February 2, 2018

File No. 90420.01

**Re: Report, Well Testing Proposal Review, Proposed 40B Housing Project  
59 North Main Street  
Sherborn, Massachusetts**

**Attachment 1**  
**Site Plan with Wells**  
**Well Drilling Permits and Reports**  
**Hydrofracturing Notes**

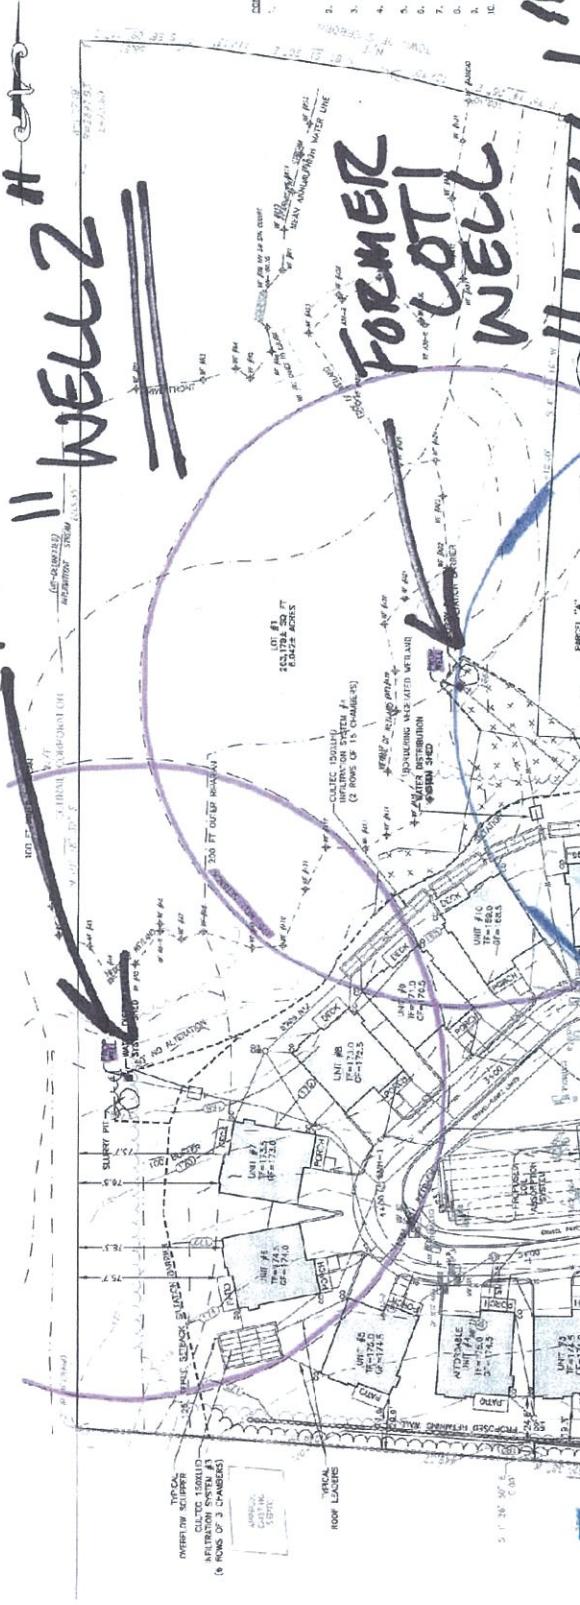
The wells have already been drilled and are located as shown on the attached plan (Attachment 1), provided by EDC and modified by Nobis. The wells are known as Well 1 (eastern well) and Well 2 (western well) and were permitted in 2015 for a previously-proposed 3-lot subdivision on Lot 1 and Lot 3, respectively. Drilling records (Attachment 1) show that Well 1 encountered bedrock at a depth of 9 feet below ground surface (ft bgs) and has a total depth of 700 ft.; the

Based on information provided to Nobis by the Applicant, there are 5 abutter wells of note:

- 61 North Main St. (Marthinsen) – NE of site; about 170 ft from Well 1; about 400 ft from Well 2
- 60 North Main St. – E of site (across North Main St.), about 300 ft from Well 1; about 480 ft from Well 2
- 58 North Main St. – E of site (across North Main St.), about 370 ft from Well 1; about 480 ft from Well 2
- 54 North Main St. – E of site (across North Main St.), about 430 ft from Well 1; about 520 ft from Well 2
- 55 North Main St – SE of site; about 500 ft from Well 1; about 500 ft from Well 1; about 470 ft from Well 2

These wells are shown on the plan in Attachment 1.

- The Applicant should be asked to monitor up to 3 abutter wells, in the following priority:
  1. 61 North Main St. – This well is the closest to the SV wells and should be monitored if permission is granted and monitoring is feasible, as described above.

2. 55 North Main St. – This well is the second closest well to Well 2 and in a different direction from the site than the other wells under consideration.

3. One of the 3 wells on the other side of North Main St.
- Also, if a Stilling Well cannot be installed "easily", the Applicant should not be expected to proceed with monitoring that well. For example, if the driller installing the Stilling Wells believes that the Stilling Well can only be installed if the well pump is pulled, then this well should not be monitored. Any action that may disrupt the abutter's water supply or that the driller feels is too risky should not be undertaken.
